LETTER SHOWING SEWER CAPACITY

Re: 3801 Briarcliff Rd, NE
18th Dist, LL 193
Lakeside HS
NFPC

**DEKALB COUNTY, GEORGIA
DEPARTMENT OF WATERSHED MANAGEMENT
CAPACITY ANALYSIS**

LAKESIDE HS - CAPACITY EVALUATION

3801 Briarcliff Rd. NE. - Capacity Request - Hydraulic Model Run Results (Nov. 2018) - with all pending development peak flow added
Dry Weather Run - Sewer tie-in at 18-193-s092

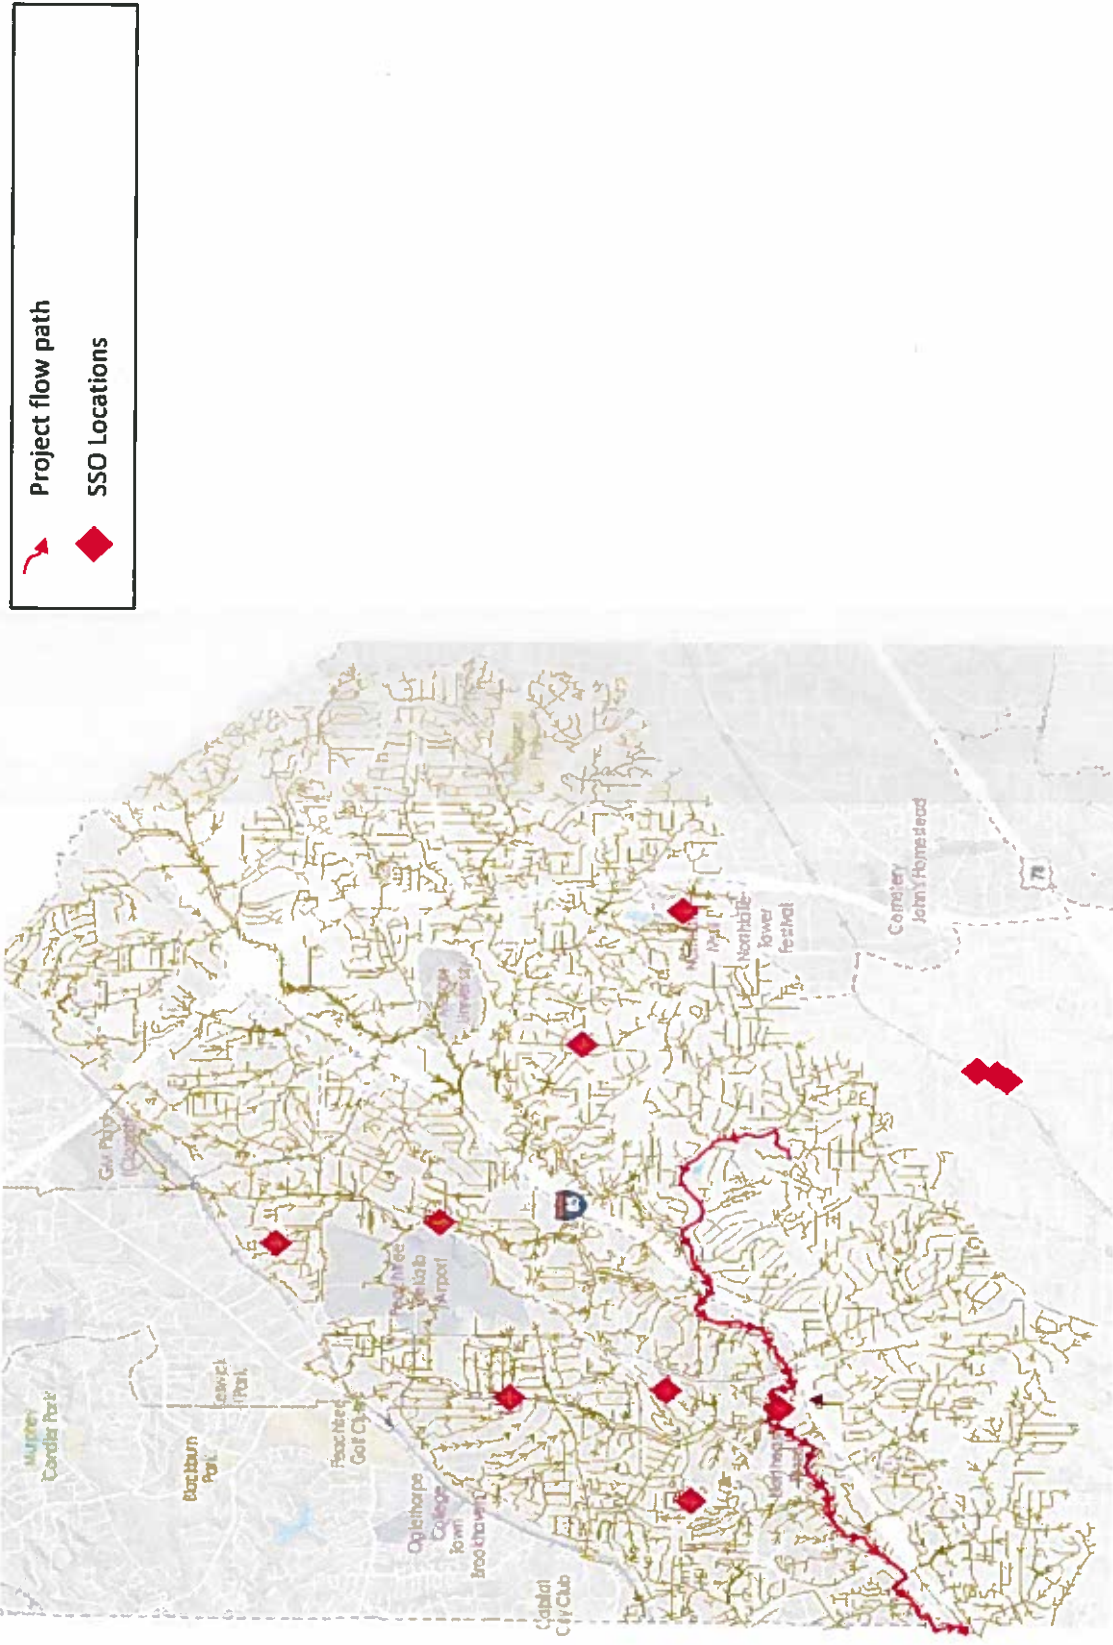
Project flow path
	SSO Locations

Model Run Version: NFPC_Scenario #1 2015 DWF_2017GISupdate_withSCRPeakFlows_DWFRun_VUO11072018

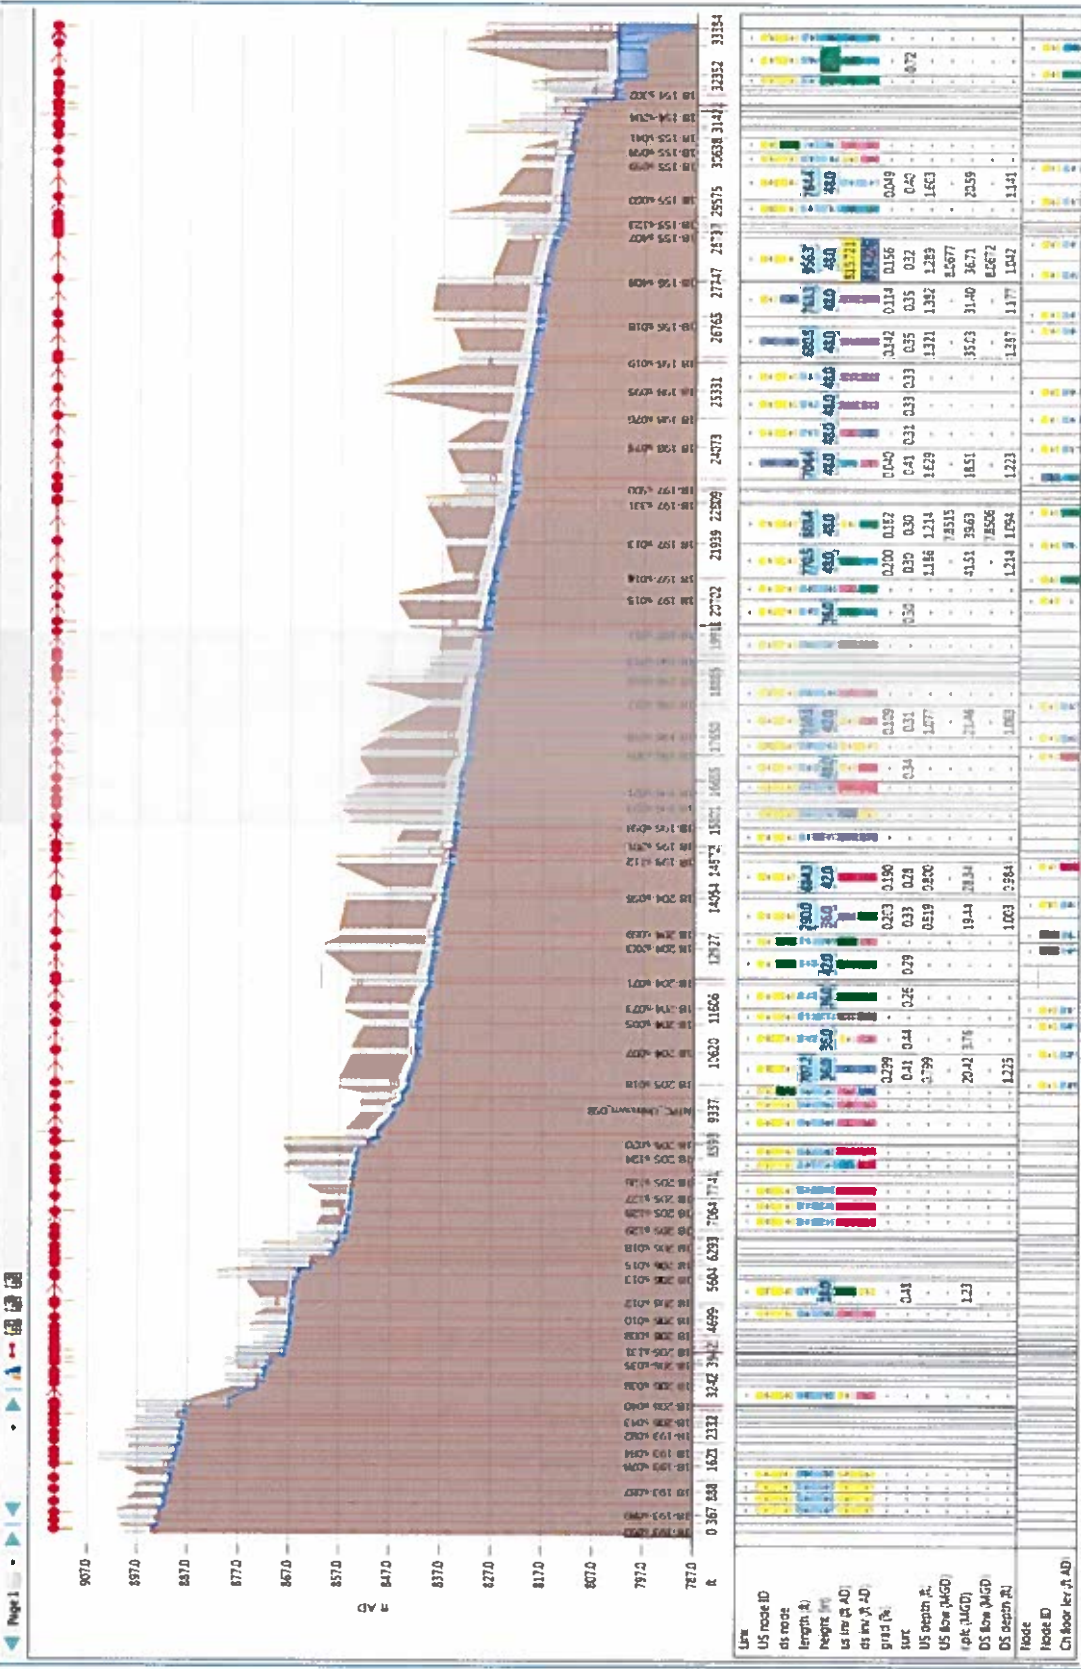
Entire Section. No simulated surcharge (d\O greater than 80%).

MMADF – Sewer tie-in at 18-193-s092
Model Run Version: NFPC_Scenario #4 2015DWF+MMADF_Ext_2017Update_MMADFRun_withSCRPeakFlows_VUO11072018

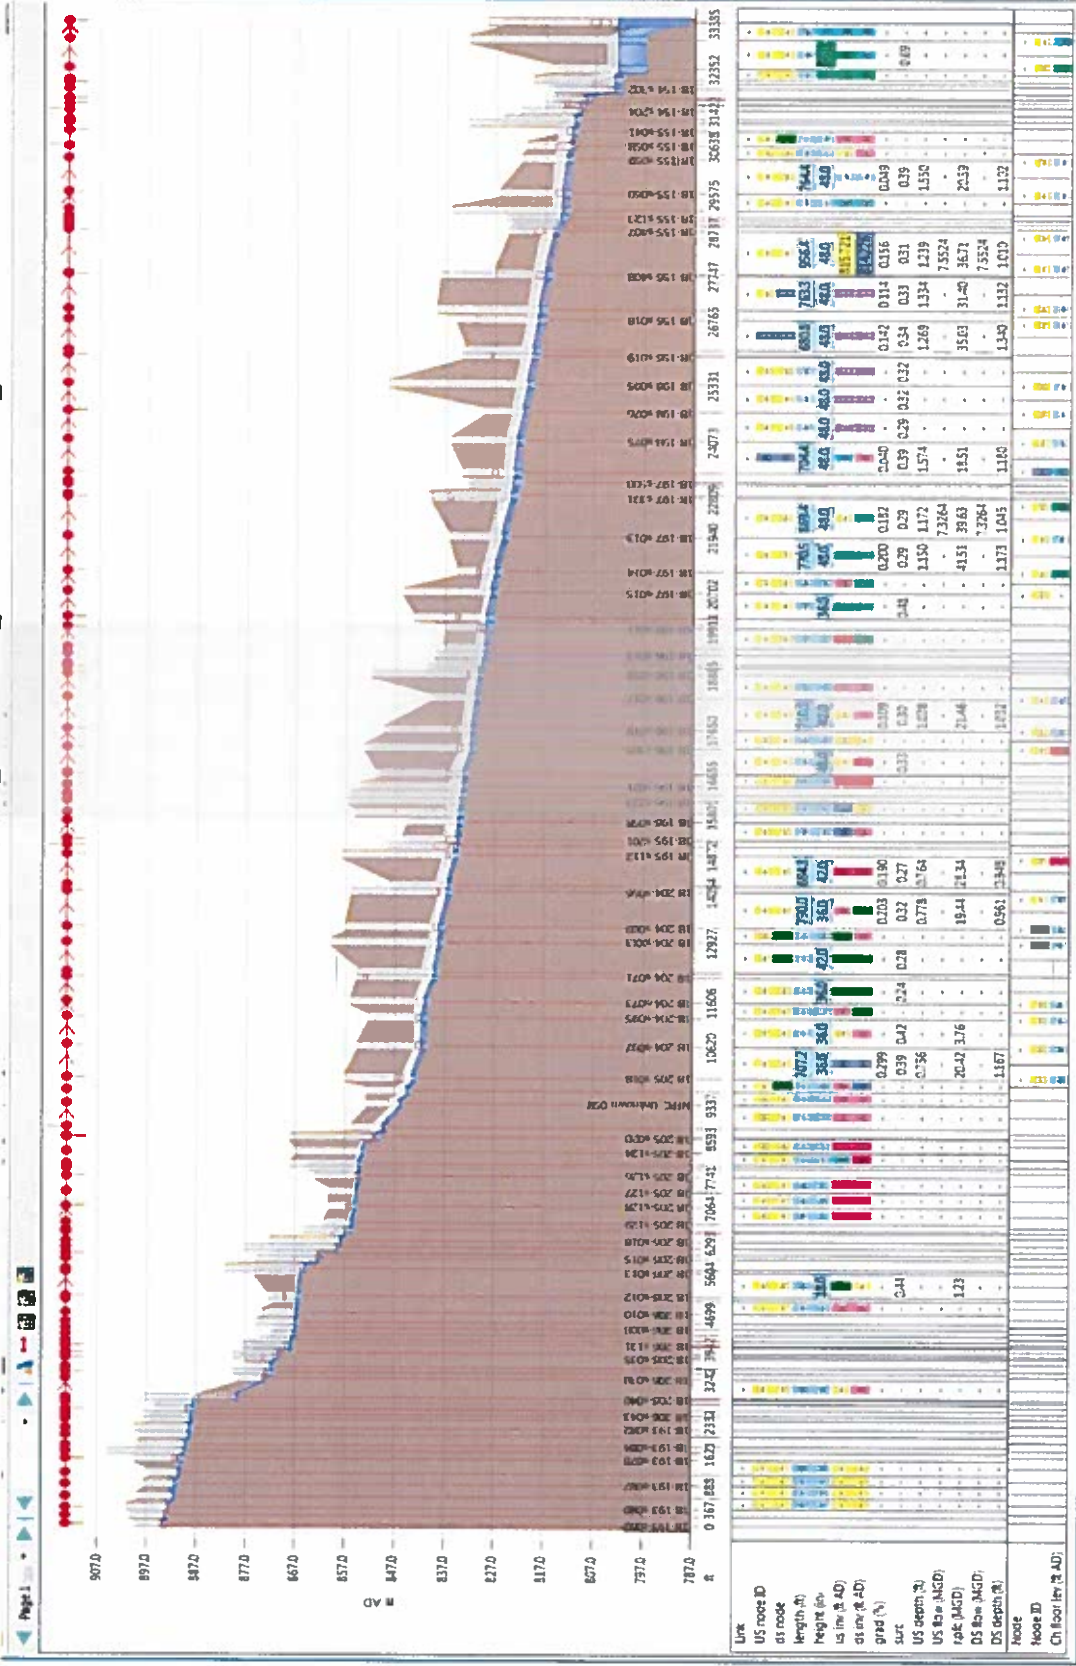
Entire Section. No model predicted flow over the full pipe depth, under Max. Month Average Daily Flow model.
